Topic

Follett Corporation has recently increased its torque setting for the stream divider on all Horizon 1000, 1400, and 1650 lb. ice machines. Previous models have a lesser torque value that, under certain circumstances, may cause the stream divider to back out. When this happens, the ice can become soft, wet, and smaller resulting in excessive load on the gear motor. This excessive load can cause an over-torque (hi-amps) error. The poor quality ice may also result in jamming in the transport tube, causing the ice machine to shut down on a premature time delay. Another symptom of poor quality ice is dispenser jamming or 'snowy' ice being dispensed.

Fig. 1

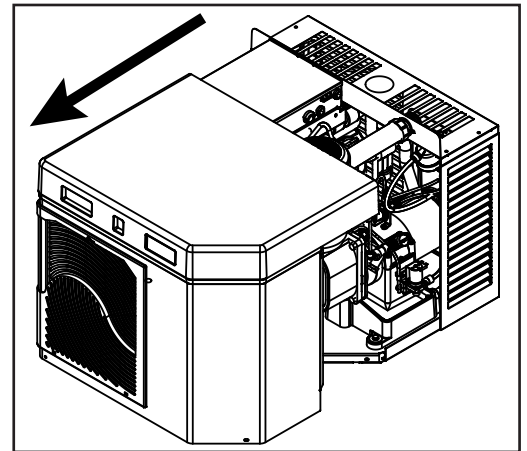
1. To access the stream divider, remove the front cover (Fig. 1).

Fig. 4

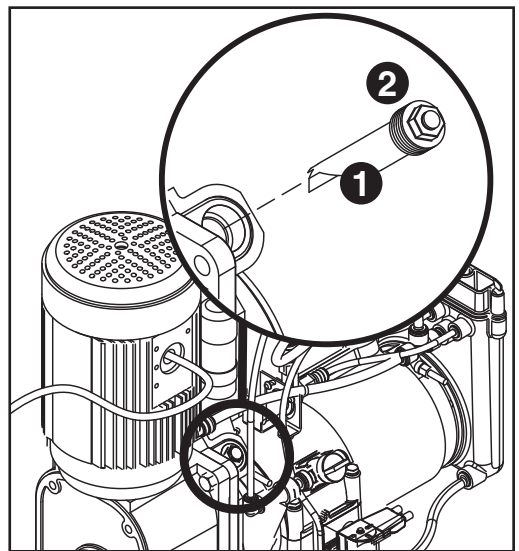
- Lubricate the body of the stream divider with a thin coat of petrol gel (Fig. 4.1).
- Apply blue food grade thread lock to the stream divider's threads only (Fig. 4.2).
- Insert and firmly tighten stream divider to 500 in/lb.
